July 16, 2019
BOARD OF COUNTY COMMISSIONERS
ORANGE COUNTY, FLORIDA
ADDENDUM NO. 2 / IFB NO. Y19-776-TA
PUMP STATION PACKAGE 22 IMPROVEMENTS

ORANGE COUNTY
 R/R PACKAGE 22 PUMP STATIONS
 CIVIL
PUMP STATION 3337 - WHISPER LAKES 7
 PROPOSED SITE PLAN

| DRAWING NO.: | C101 |

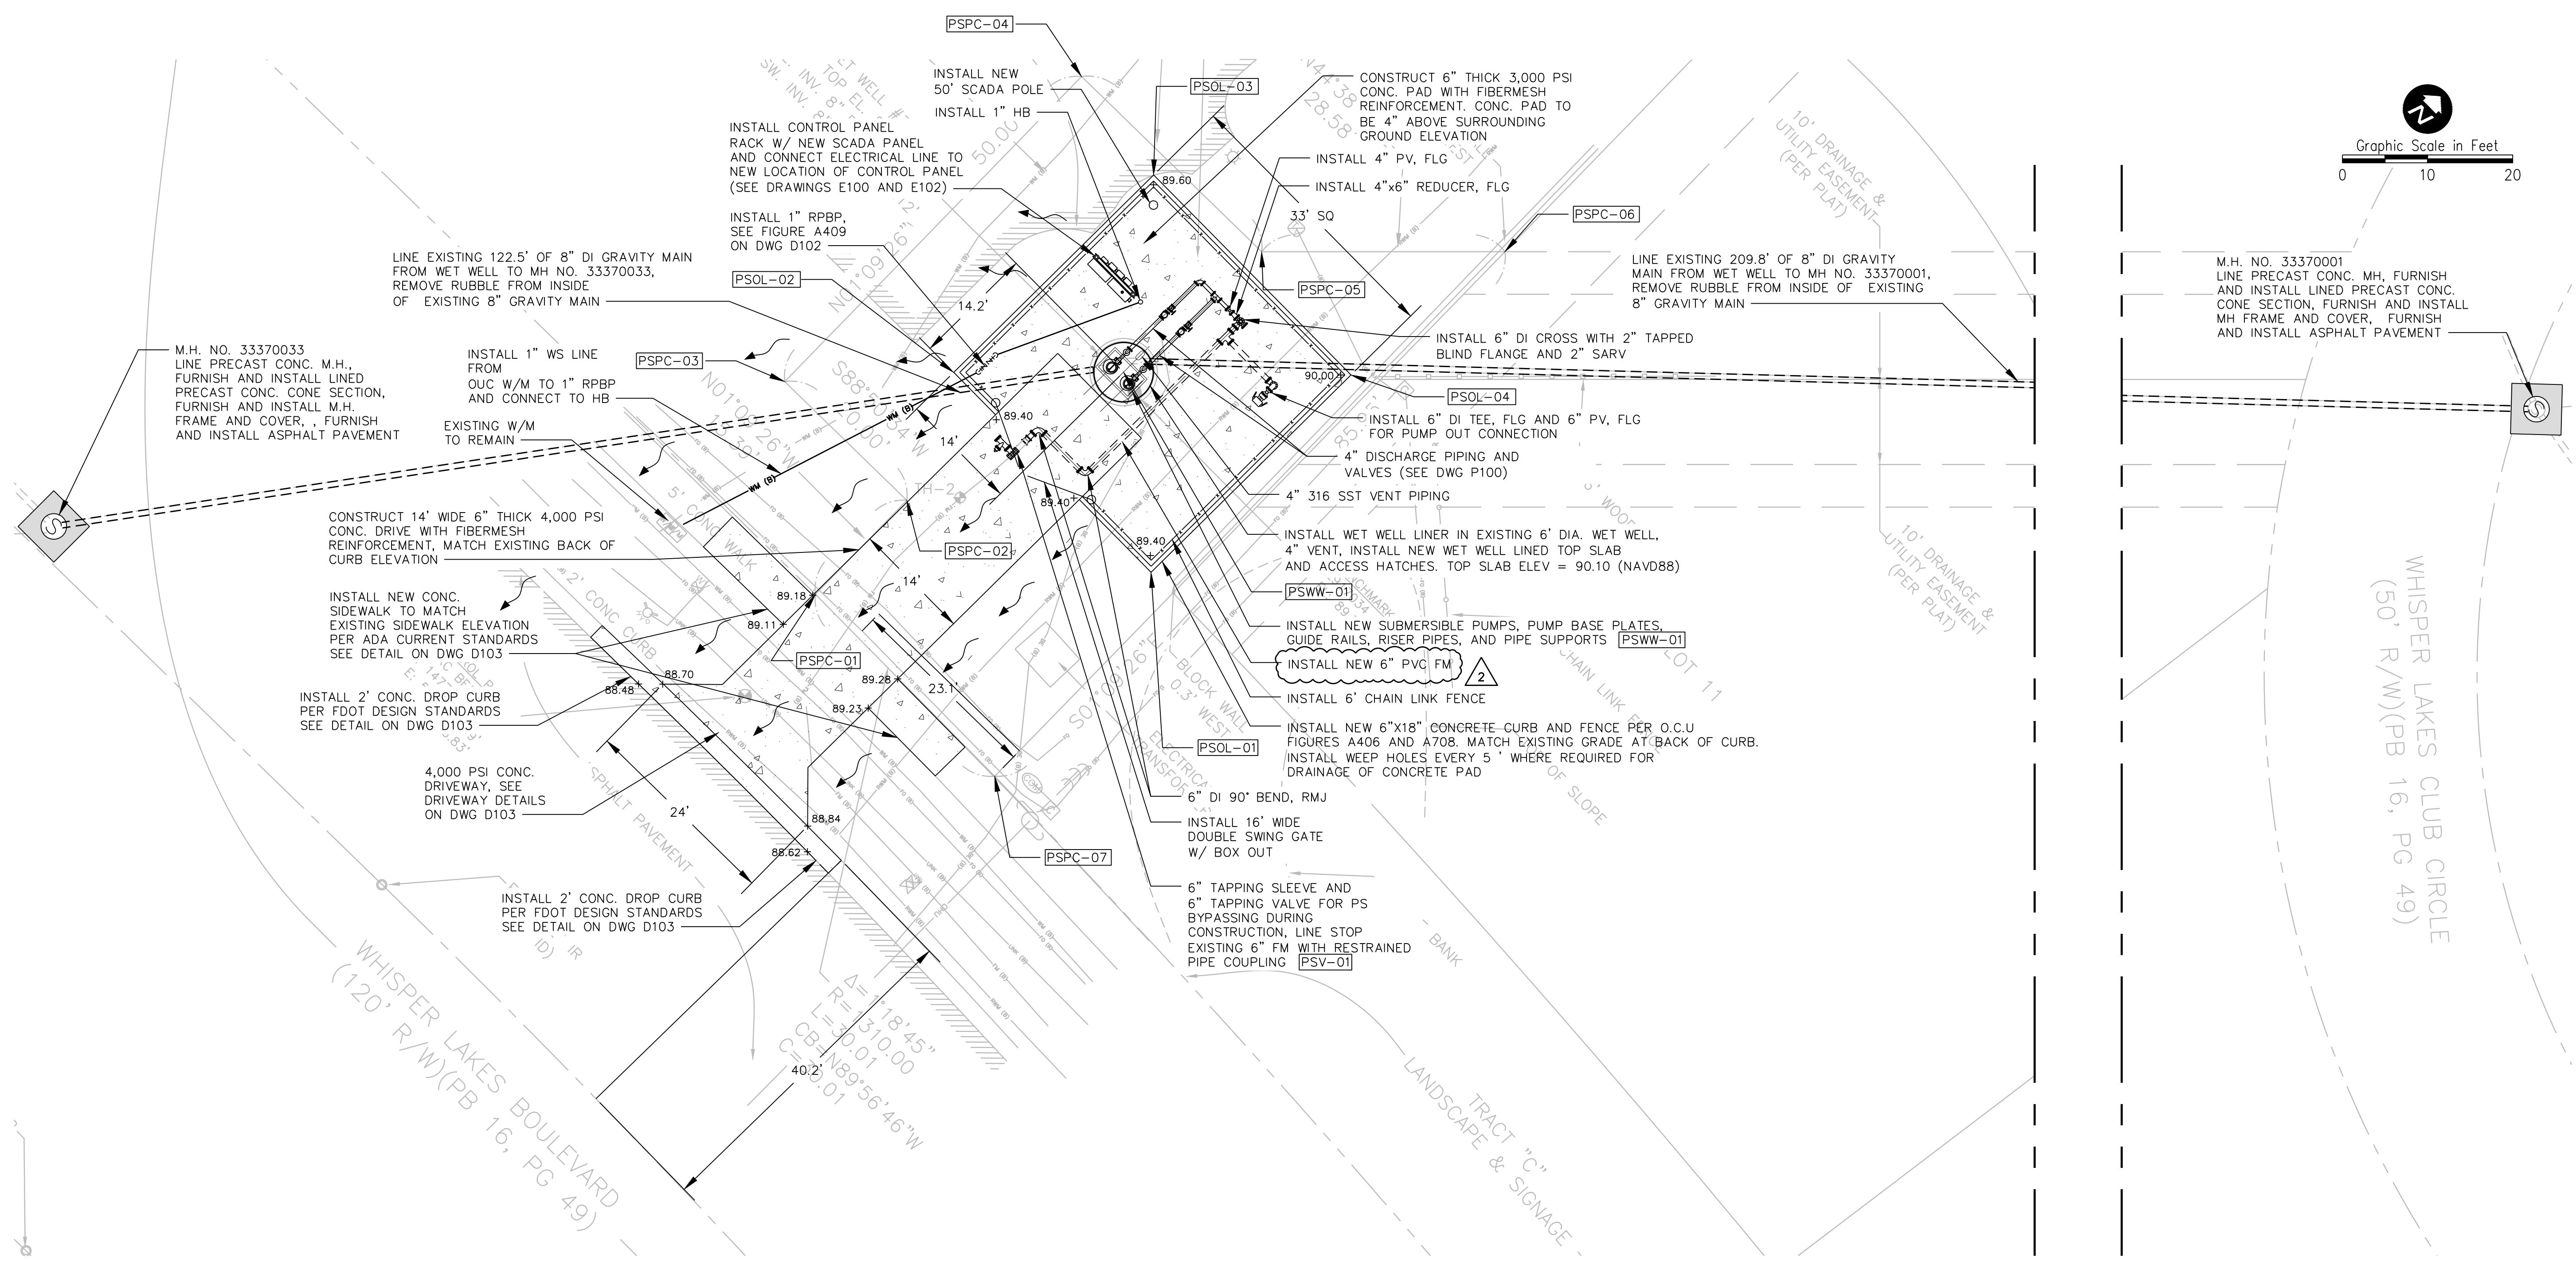
1. Q. Sheet 11, Pump station 3337 calls for 6" DIP however, sheet 20 calls for 6" PVC. Are we to use PVC material for this and all stations underground force mains?

A. See revised Drawing C101. Underground force main to transition to PVC as shown on the P drawings.

| DRAWING NO. C201 | SHEET NO.: 13 OF 50 |

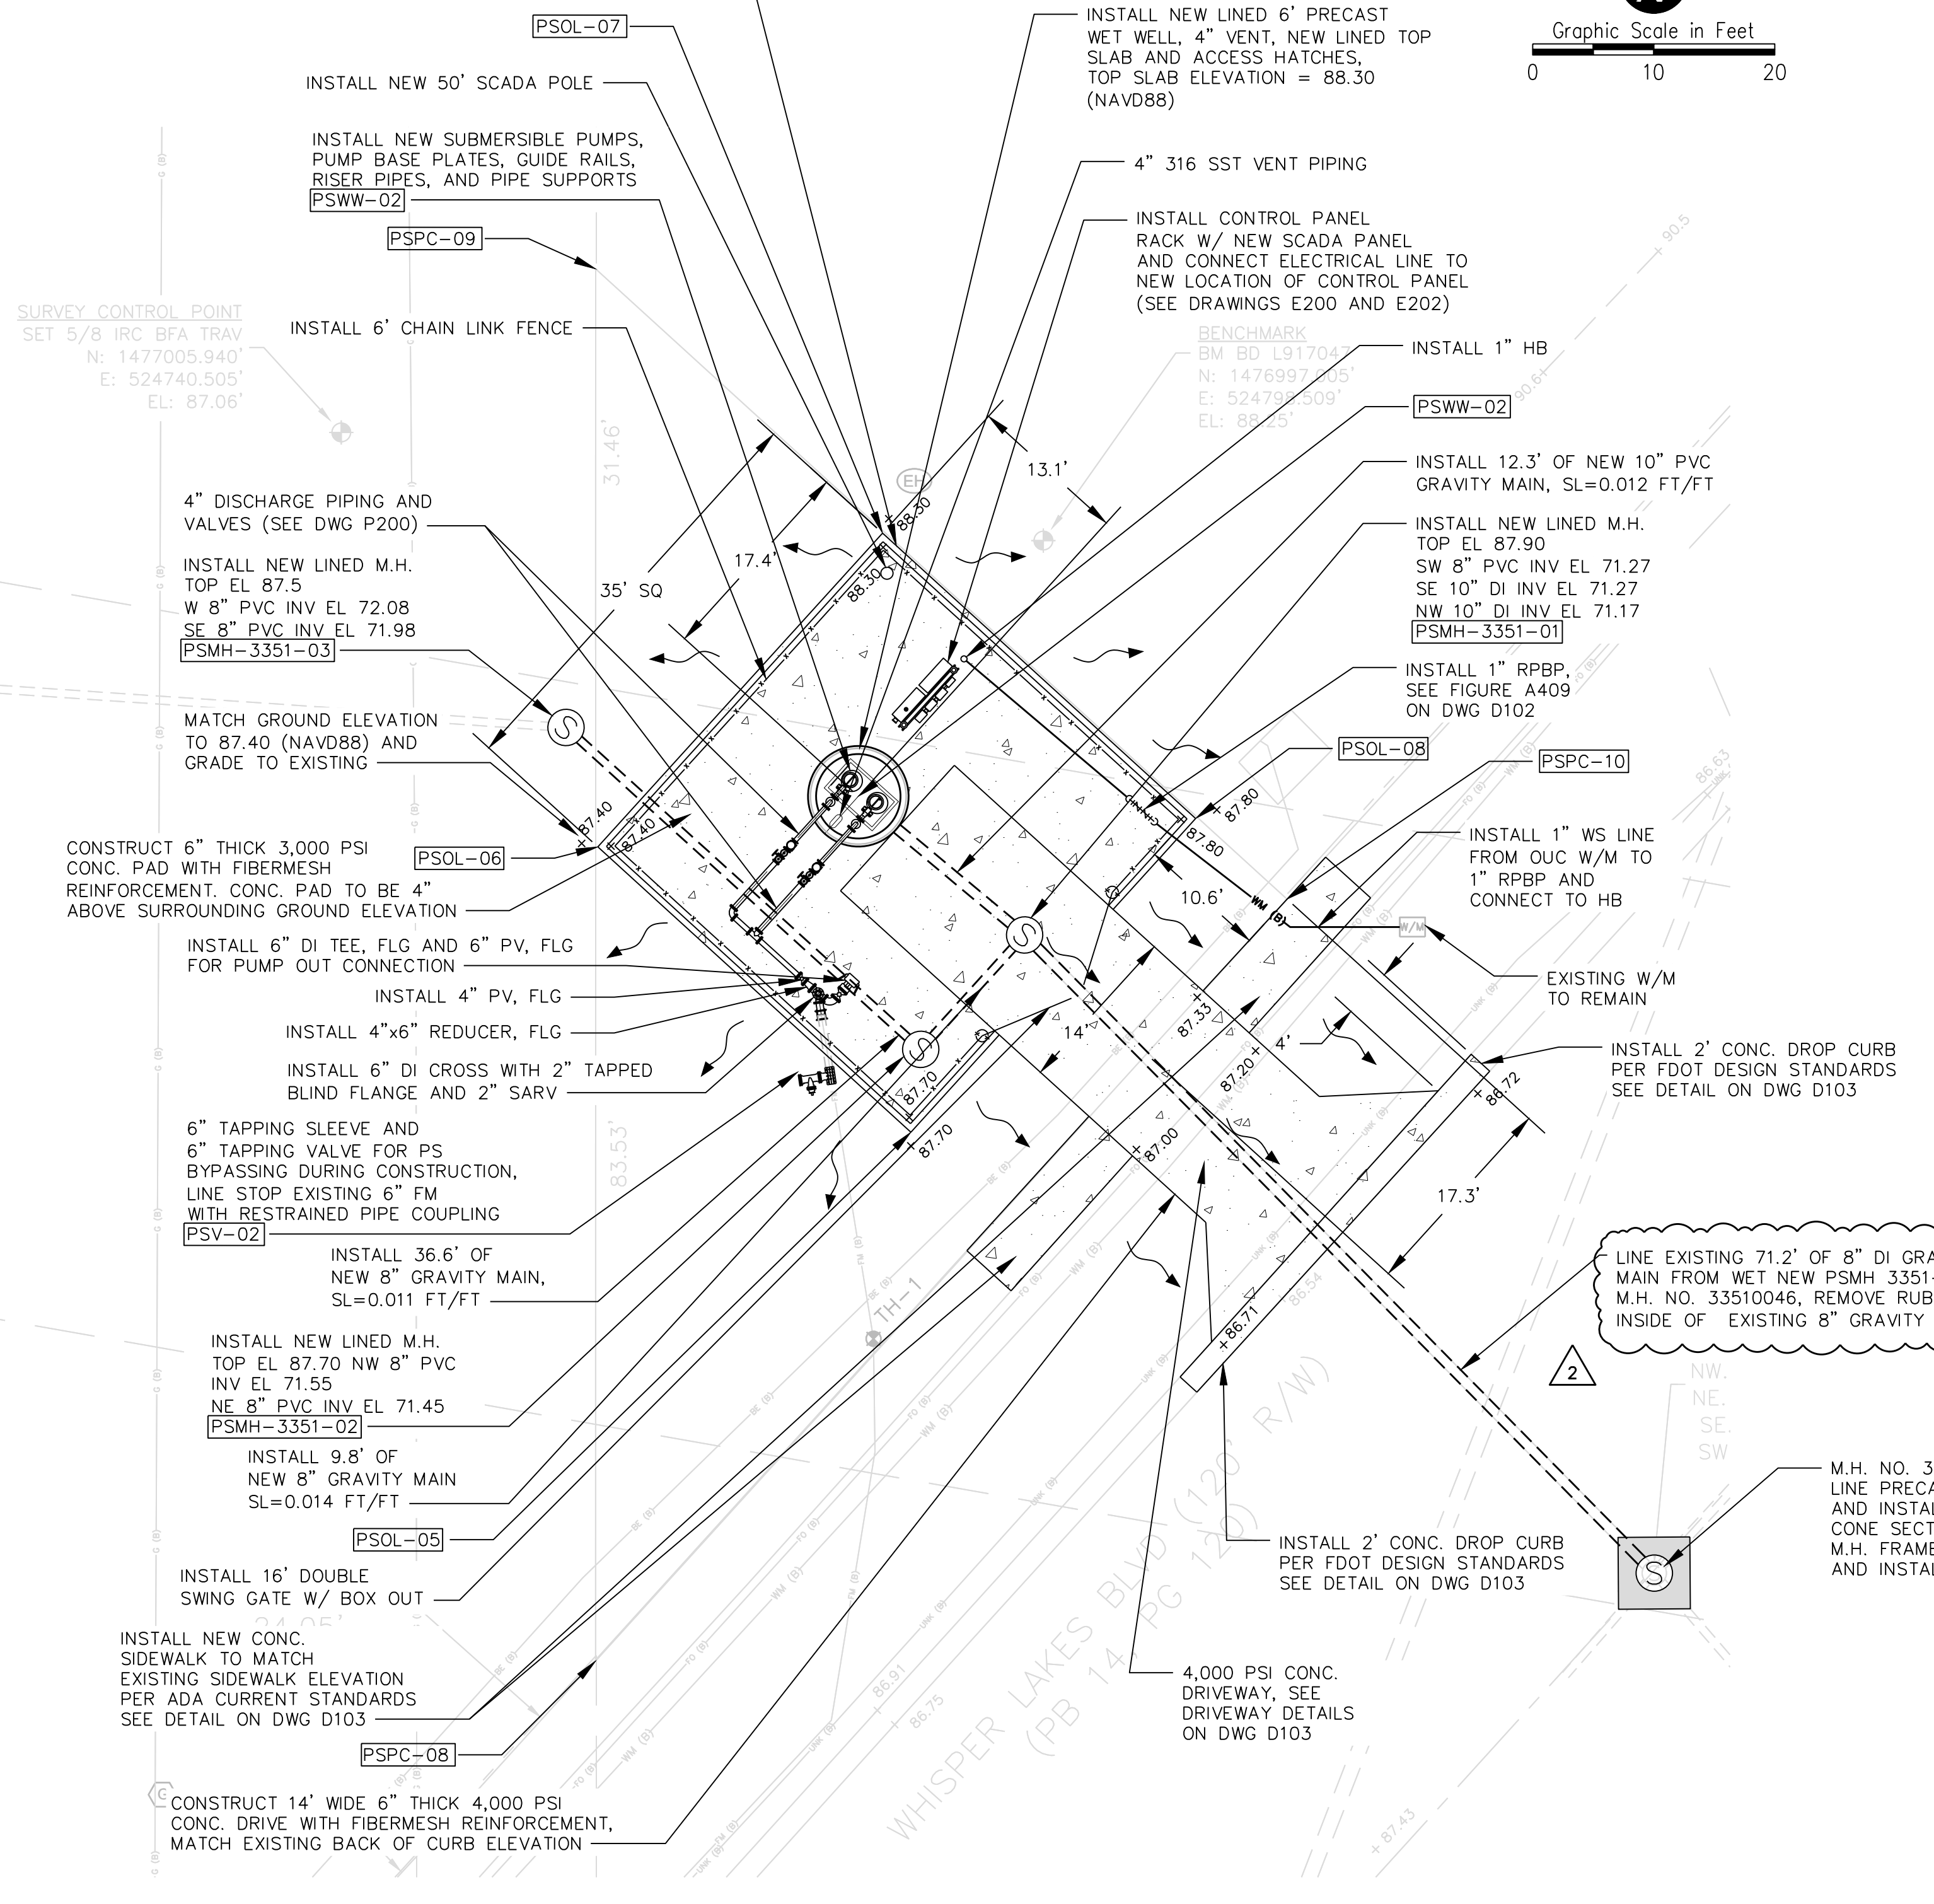
2. Q. Pump Station 3351 calls for 8" lining of 209.8 lf however this only scales to approx. 73 LF from Manhole 33510046 to MH 3351-01, please confirm we are to only line between these limits and not past MH 33510046.

A. See revised Drawing C201. The limits to be lined are between MH 33510046 and MH 3351-01.

| DRAWING NO. C501 | SHEET NO.: 19 OF 50 |

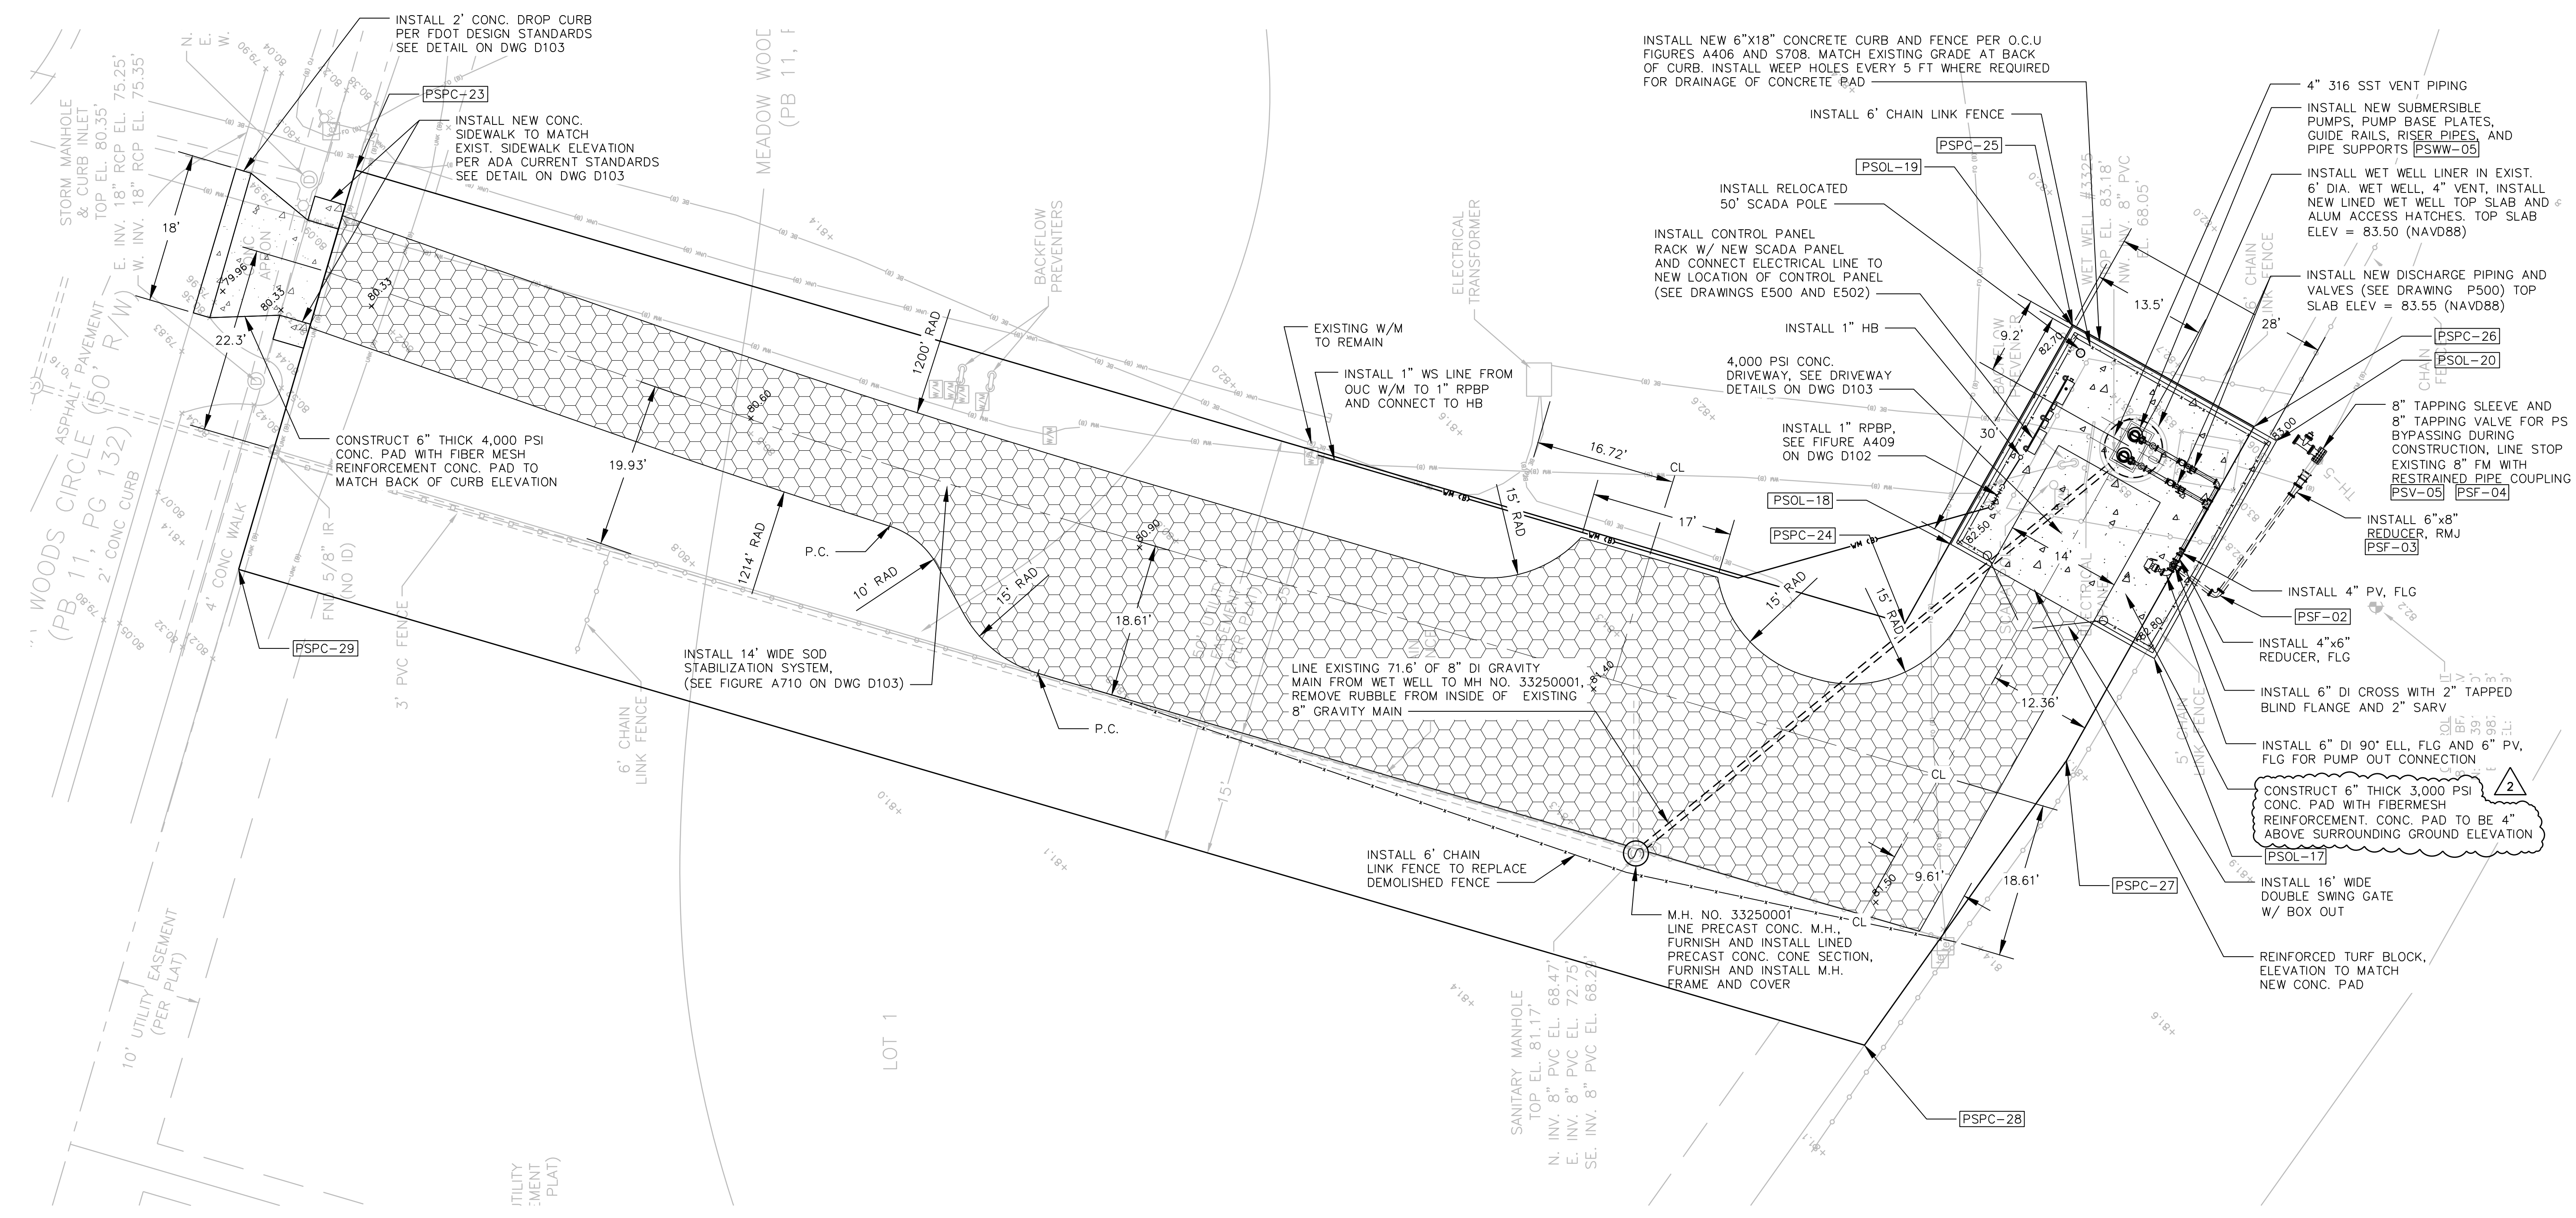
4. Q. Concrete pad at Pump Station 3325 calls for this to be 6" 4,000 PSI w/fibermesh, however all the other Pump Stations calls for 3,000 PSI, please confirm it is the County's intent to use 4,000 PSI at this pump station for the concrete pad.

A. See revised drawing C501. Concrete pad shall be revised to 3,000 PSI for PS 3325.

STANDARD ROADWAY MILL AND RESURFACING WITH OPENCUT CROSS SECTION DETAIL

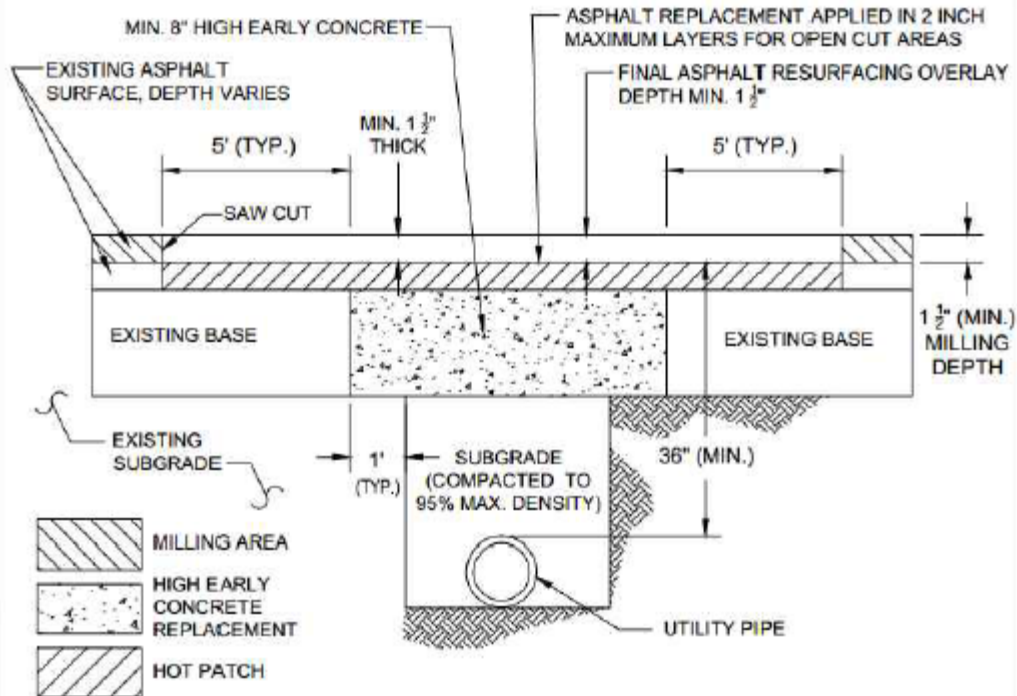
3. Q. Please provide a thickness for Milling and Resurfacing of Pump Station 3390 and also what type of asphalt we are to use for resurfacing.

A. See attached standard roadway mill and resurfacing detail to be included in the drawings.
